CITY OF WESTMINSTER			
PLANNING	Date Classification		
APPLICATIONS COMMITTEE	30 August 2016	For General Rele	ase
Report of	Ward(s) involved		
Director of Planning	Westbourne		
Subject of Report 42 Blomfield Villas, London, W2 6NQ,			
Proposal	Use of basement as dwellinghouse (Class C3), installation of windows to the front and rear elevations, installation of stair within front lightwell, creation of lightwell to rear and installation of railing around lightwell to rear elevation.		
Agent	Agent Lambert Smith Hampton		
On behalf of	City West Homes		
Registered Number	16/06072/COFUL	Date amended/	
Date Application Received	28 June 2016	completed	26 Julie 2016
Historic Building Grade	uilding Grade Unlisted		
Conservation Area	Maida Vale

Reference: 16/06072/COFUL

# 10. KEY DRAWINGS

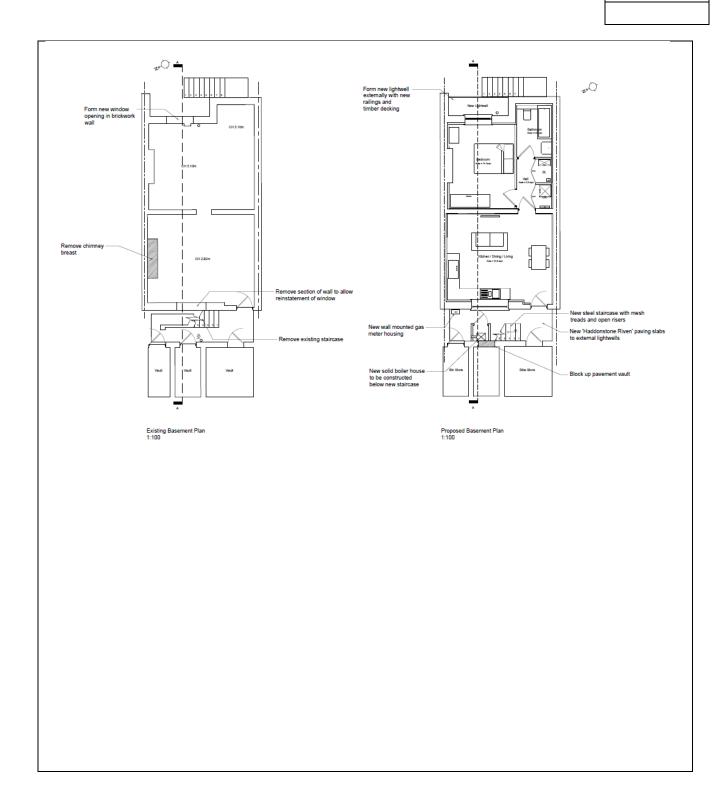
The local amenity society have commented that the proposed window is unsympathetic with the host building, causing harm to the character and appearance of the Conservation Area. Additionally they state the replacement stairs should be solid rather than metal.

On the front elevation it is proposed to remove the existing solid staircase which sits against the front elevation, introduce a replacement metal staircase against the front vault elevation and to insert a window on the front elevation. The new timber sash window sits directly below the window at ground floor level. The comments from the local amenity society are noted. However, given that the window is to be located on the most subservient level on the front elevation, the scale of the window and the minimal architectural detailing surrounding it is considered to be appropriate for this location, preserving the character and appearance of the building within its setting of the Maida Vale Conservation Area. As proposed the window is of an appropriate scale, reflects the architectural style and materiality of the host building and therefore is considered to be in accordance with UDP Policy DES 5.

Whilst the loss of a solid staircase is regrettable, in order to achieve light into the lower ground floor level the staircase had to be relocated away from the front elevation. Whilst

its replacement with a solid stair would be welcomed, it would be difficult to achieve this within a lightwell of this scale where access to the vaults is required. The staircase is lightweight, subservient in scale and design and maintains the interpretation of the proportionality of the building as a mid-terrace house and consequently the uniformity of the streetscene. Nevertheless a condition is recommended requiring the new staircase to be painted black and maintained as such in order to ensure it is keeping with the metal work to the front boundary and on the elevation. Furthermore the principle of this alteration has previously been accepted on this street (RN: 11/08882/COFUL) and therefore a refusal would be difficult to sustain in design terms.

To the rear the alterations involve the excavation of a lightwell, the depth of which does not project beyond the rear elevation of the shallow closet wings. Railings will be introduced around the lightwell and a window is to be inserted on the rear elevation. During the course of the application the treatment within the lightwell has been amended to stone following concerns raised with the suitability and durability of timber decking; this alteration is acceptable. The detailed design and scale of these alterations are in keeping with the existing arrangement to some of the rear elevations of the buildings within this terrace and therefore they are not contentious in design terms.

4 Notwithstanding details shown on the approved drawings the new metal staircase and the new railings shall be painted black and maintained as such hereafter.

Notwithstanding details shown on the approved drawings the new windows hereby permitted shall be white painted timber and maintained as such.
